Pre-Application Briefing to Committee

Reference No: PPA/2021/0019

Address: Highgate School North Road London N6 4AY

Proposal: A series of planning applications for the re-development of the Highgate School sites as follows:

Figure 17: Proposed North Elevation Dyne House

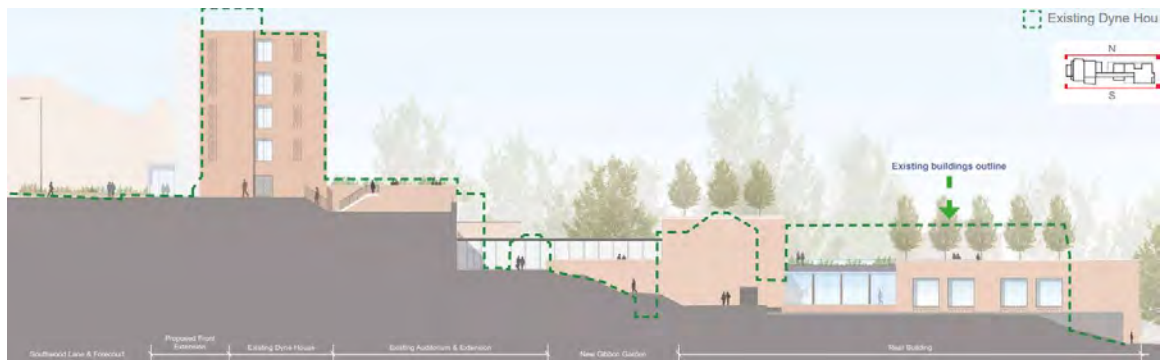
be acceptable. The land levels drop away significantly to the rear of Dyne House. It is proposed to construct the replacement rear buildings into these dropping land levels. The elevation drawing at figure 12 indicates that the replacement buildings would not be notably larger in terms of height, when compared with the existing buildings. The form and materials of the replacement buildings appear to be complementary to the main Dyne House building. The proposed new MUGA at the very rear of the site could be acceptable in design terms although further details will be required to ensure it is visually compatible with the other proposals on the site and to demonstrate how it addresses Core Objective 4 of the Neighbourhood Plan regarding greening the Parade Ground area.

7.11. Pre-application assessment and QRP comments suggest that the proposals at Dyne House and at the Island Site could be acceptable in terms of design, subject to additional details being provided and further consideration by officers. There is an opportunity to enhance the visual contribution Dyne House and the Island Site makes to the character of the Conservation Area.

Figure 21: Existing and proposed massing of the MSC

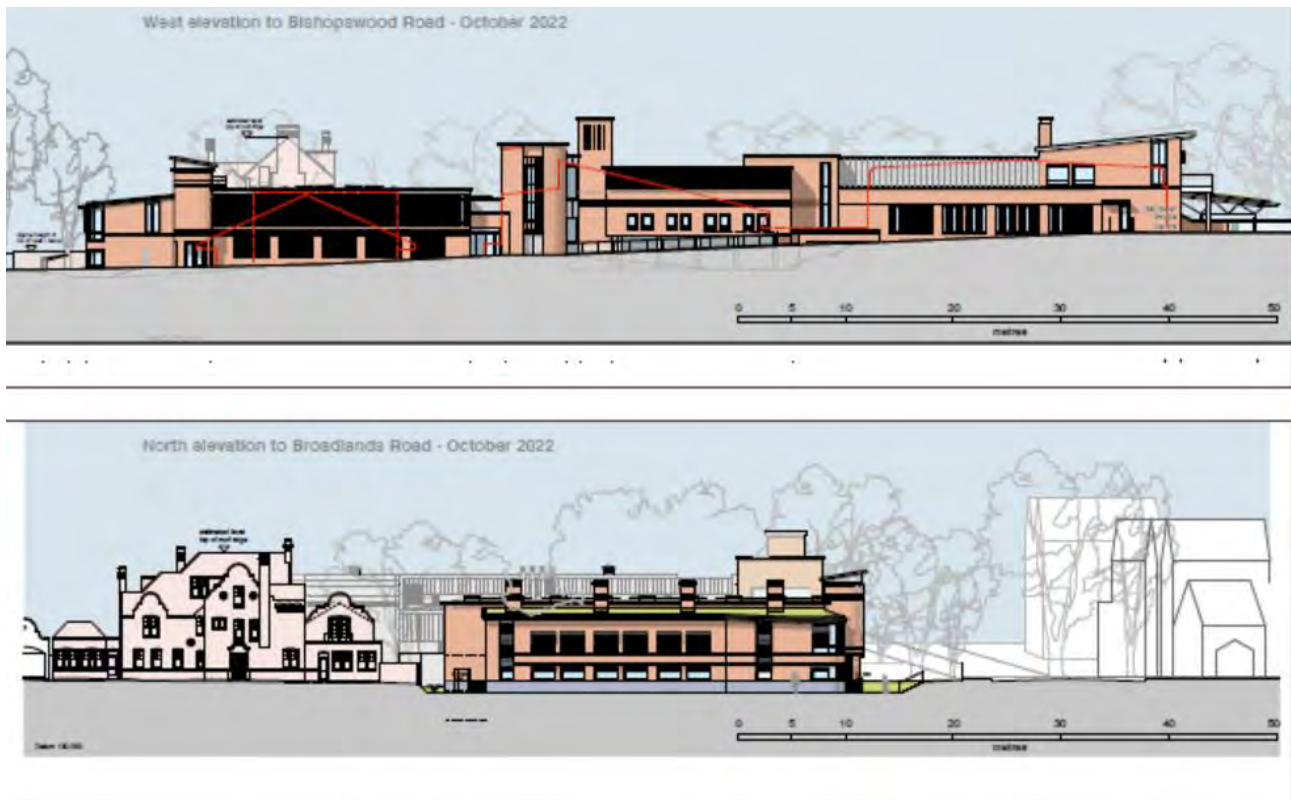
7.25. The buildings are considered at this stage to be of an appropriate scale and massing and a high-quality contemporary design. They would be finished with a robust palette of brick, stone and other suitable materials that would provide a distinctive modern appearance in this area. Officers consider that subject to further details, the design of the alterations and extensions to the existing buildings and the design of the new buildings would preserve and enhance local heritage assets.
